From: Nanette Gilles
To: Eddie Grant; Tom Mundy
Date: Fri, Jun 11, 2004 10:44 AM
Subject: DRAFT REQUESTS FOR ADDITIONAL INFORMATION

Exelon Early Site Permit Application **Site Safety Analysis Report** **Requests for Additional Information (RAI)**

Exelon Early Site Permit Application SSAR Section 2.3, Meteorology Requests for Additional Information (RAI)

Exelon Early Site Permit Application **SSAR Section 3.4.1.6, Security Plan** **Requests for Additional Information (RAI)**

RAI 2.3.2-3

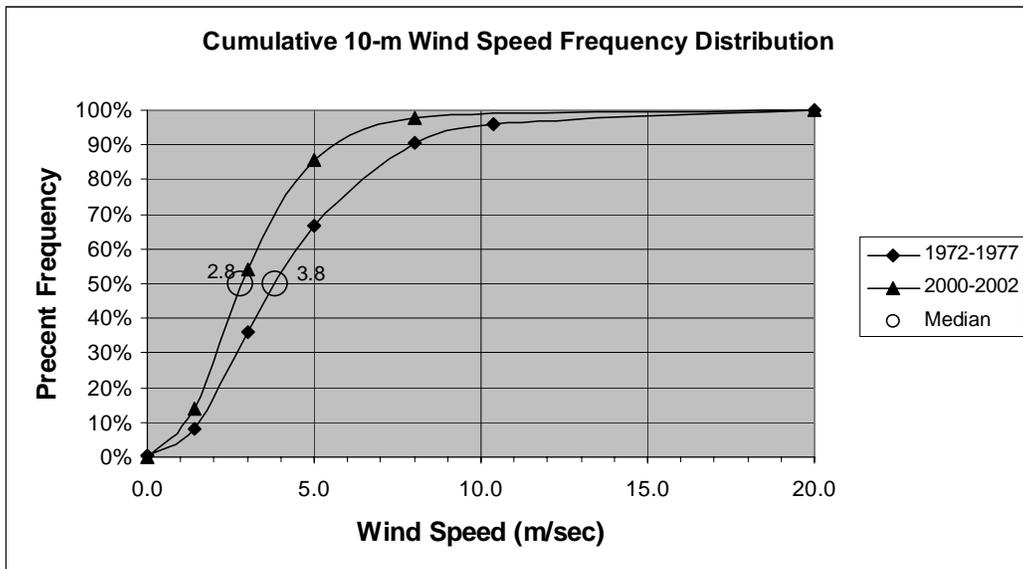
The onsite 10-m wind speed frequency distributions presented in SSAR Table 2.3-8 show a general shift towards lower wind speeds in the more recent data. In particular, a plot of cumulative wind speed frequency distribution shows a median (50%) wind speed value of 2.8 m/sec for the 2000-2002 period of record as compared to a median wind speed value of 3.8 m/sec for the 1972-1977 period of record. Please explain what might have caused these differences in reported wind speed frequency distributions between these two periods of record.
